MEMORANDUM

Subject: *Menlo Park El Camino Real/Downtown Specific Plan Bicycle-Related Comments – Tasks O, P, and Q*

SJ09-1089

This draft memorandum responds to the City of Menlo Park's comments dated October 20, 2011 on the *Menlo Park El Camino Real/Downtown Specific Plan* regarding bicycle facilities. Based on the comments, Fehr & Peers analyzed roadway segments for potential bicycle lanes and other bicycle related facilities/considerations:

Menlo Avenue, University Drive to El Camino Real
DESIGN SOLUTION
 -Stripe 5'-wide Class II Bicycle Lanes

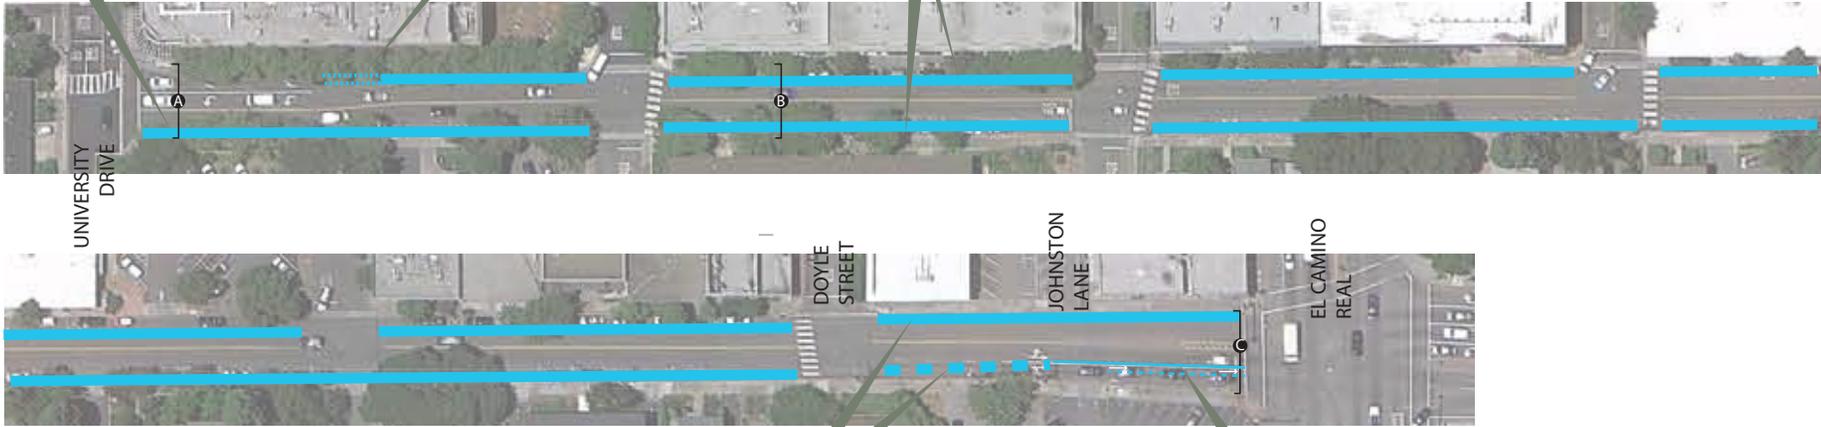
On Menlo Avenue, one parking lane would need to be removed in order to accommodate a bicycle lane within the existing right-of-way. An illustration of how bike lanes would be accommodated is presented on **Figure 2**. . Parking removal on the southern side of the street may be more feasible, as the southern side of the street has fewer retail uses and the northern side is closer to downtown. Thirty-four (34) parking spaces would need to be removed.

DESIGN REQUIREMENTS
 -Requires removal of one lane of parking, the southside is recommended given limited retail uses and proximity to downtown on the north side

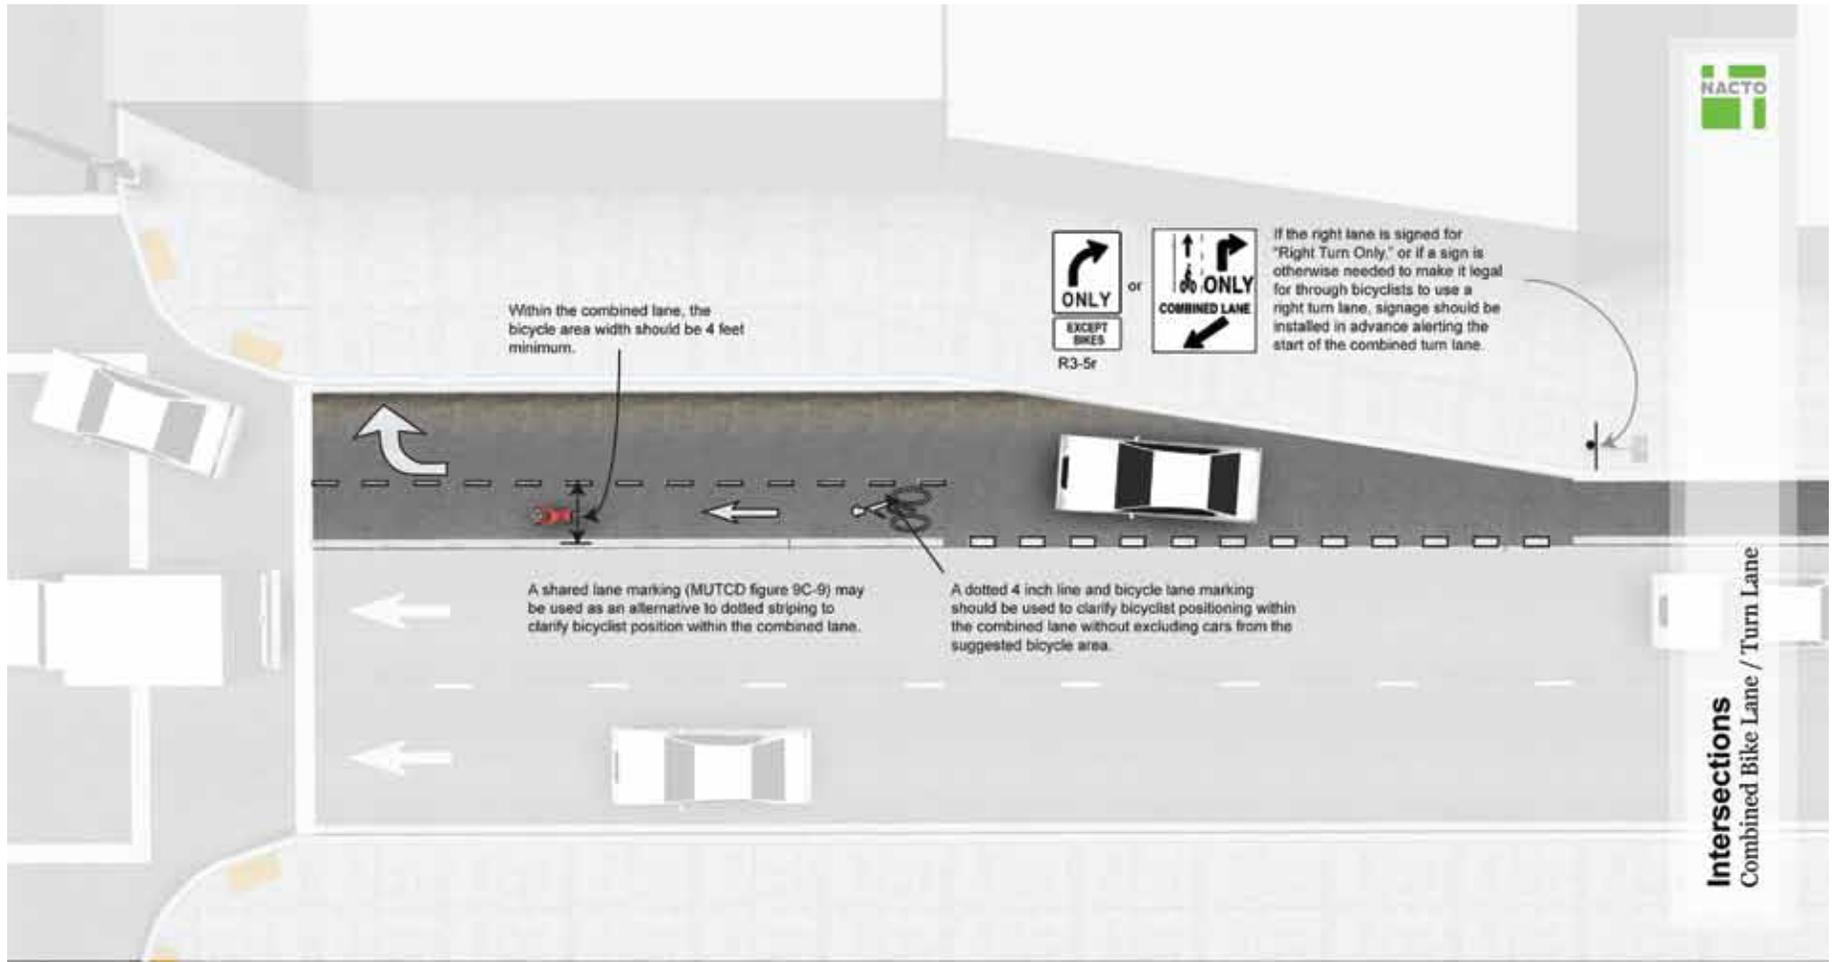
In order to accommodate 5' bicycle lanes on Middle Avenue, parking would need to be removed from University Drive to approximately 150' east of University Drive (4 south side spaces) and from 100' west of Morey Drive to El Camino Real (13 north side or 12 south side parking spaces). Parking would not need to be removed in front of Little House, where the outside travel lane is 20' in width. One concern is that vehicles parking in the perpendicular spaces adjacent to Nealon Park would have to back into the bicycle lane to exit the spaces. Parking utilization should be studied along Middle Avenue to confirm that a sufficient number of spaces would be retained if one lane was removed. As a result, Middle Avenue from University Drive to El Camino Real should be designated a "Future Class II/Minimum Class III" bikeway in the plan.

When bicycle lanes are striped, a combined bicycle lane/right-turn lane at the intersection of Middle Avenue and El Camino Real should be striped to facilitate bicycle traffic across El Camino Real to access the Middle Avenue crossing. Should automobiles be allowed to make a through movement onto a future Middle Avenue extension once the area is redeveloped, the left-turn lane could become a shared left- and through-lane, with the right-turn pocket remaining a combined bicycle lane/right-turn only lane to prevent right-hook auto/bicyclist collisions. The westbound bicycle lane would be created by narrowing the westbound through lane. The proposed mitigation measure at this intersection identified in the Draft EIR is to add a second northbound left-turn lane which would require two receiving lanes on westbound Middle Avenue. A detailed design would need to be conducted to determine the feasibility of a bicycle lane in this segment.

Prior to the intersection and gas station driveway, the bicycle lane should shift from running against the curb to its eventual alignment between the left- and right-turn pockets. This area should be demarcated by dashed white striping on the outside of the bicycle lanes, with the optional application of a 6'-wide green-colored asphalt strip to further highlight the conflict zone. This is presented conceptually on **Figure 6**.

Designate Middle Avenue as Future Class II/Minimum Class III.

Middle Avenue, between Specific Plan border & El Camino Real
DESIGN SOLUTION
 -Stripe 5' Class II Bicycle Lanes
 -Stripe combined bicycle lane/right-turn lane at intersection with El Camino Real per NACTO Urban Bikeway Guidance (striping of dashed bike transition lane may change depending on bicycle lane alignment)

El Camino Real

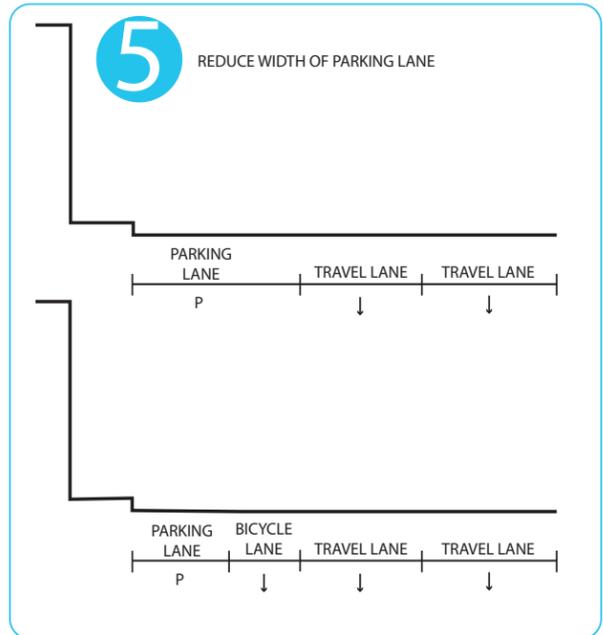
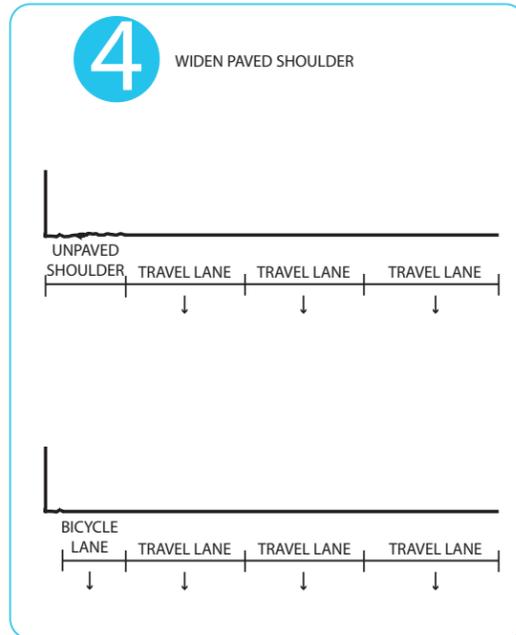
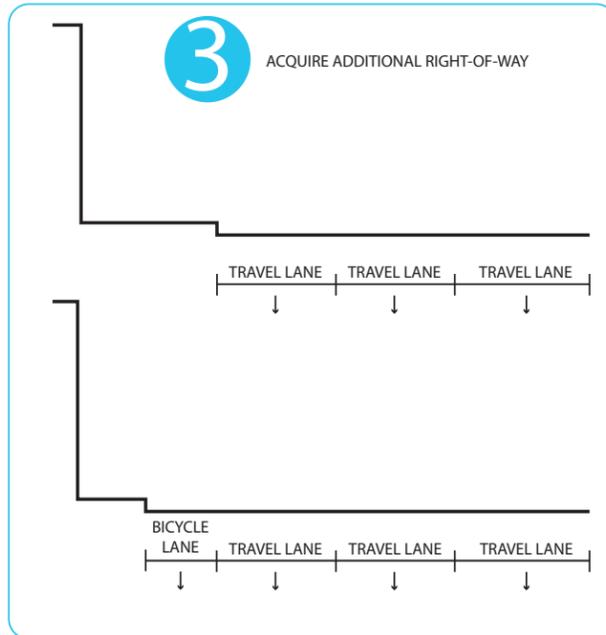
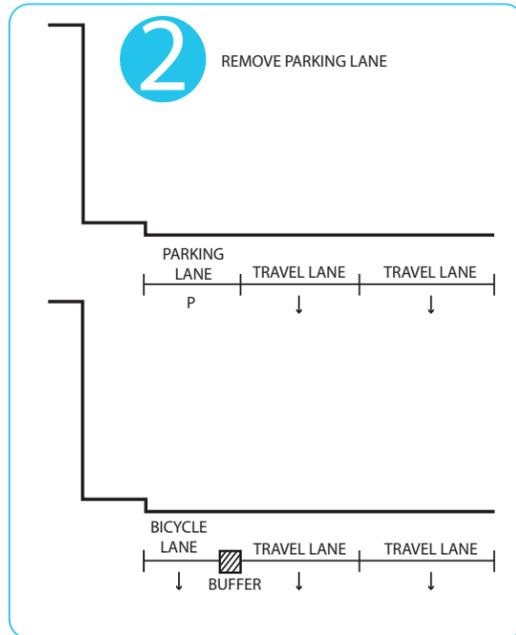
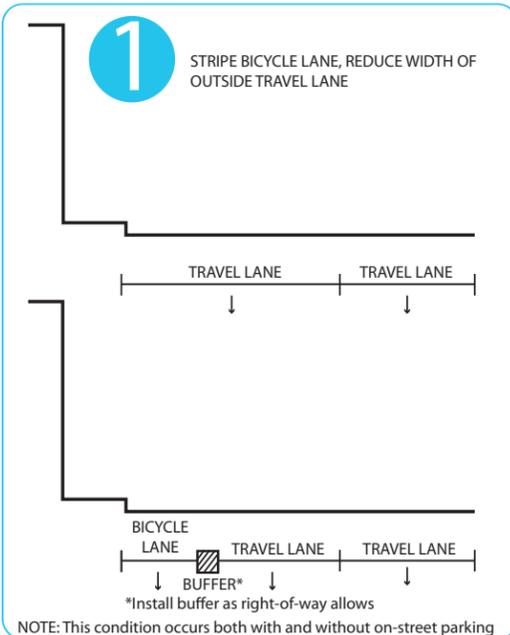
Continuous Class II bicycle lanes are feasible on El Camino Real from the Atherton town limit to Valparaiso Avenue/Glenwood Avenue in the northbound and southbound directions. Bicycle lanes are also feasible between Valparaiso Avenue/Glenwood Avenue and Menlo Avenue/Ravenswood Avenue and are discussed in the *Task A – El Camino Real Street Sections Revision* memorandum to City staff, dated February 27, 2012. South of the downtown area, there are many right-of-way constraints that make continuous bicycle lanes infeasible at present. Fehr & Peers recommends classifying El Camino Real between Encinal Avenue and the Palo Alto border as a "Future Class II/Minimum Class III" facility. In the short-term, these segments would be designated a Class III bicycle route; however, bicycle lanes would be added with parking removal and when additional right-of-way can be acquired/dedicated as properties redevelop in the future. The required changes (reduced lane widths, parking removal, and right-of-way acquisition) to accommodate bicycle lanes on El Camino Real are presented on **Figure 4**.

The majority of the Class II bicycle lanes will consist of 5' lanes; however, in some locations, sufficient width may be provided to accommodate buffered bicycle lanes. Buffered bicycle lanes are bicycle lanes that have a designated buffer space, typically striped, between the bicycle lane and the outside travel lane and/or parking lane. They may include additional measures such as soft-hit posts located in the striped buffer. Assuming sidewalk and median curb lines are not moved, the design solution – conventional bicycle lane or buffered

El Camino Real, Menlo Park/Atherton boundary to Menlo Avenue/Ravenswood Avenue
DESIGN SOLUTION
 -Stripe Class II bicycle lanes, including buffer (painted and/or soft-hit posts, as shown at right) as space allows

DESIGN REQUIREMENTS
 -Add striping for bicycle lanes by narrowing outside travel lanes or by removing parking (from Valparaiso to Oak Grove Avenues)
 -Bicycle lanes may need to be dropped at intersections, depending on right-of-way constraints

DESIGN REQUIREMENTS
 -Reduce width of outside travel lane and remove parking, as necessary
 -Acquire right-of-way in currently constrained areas
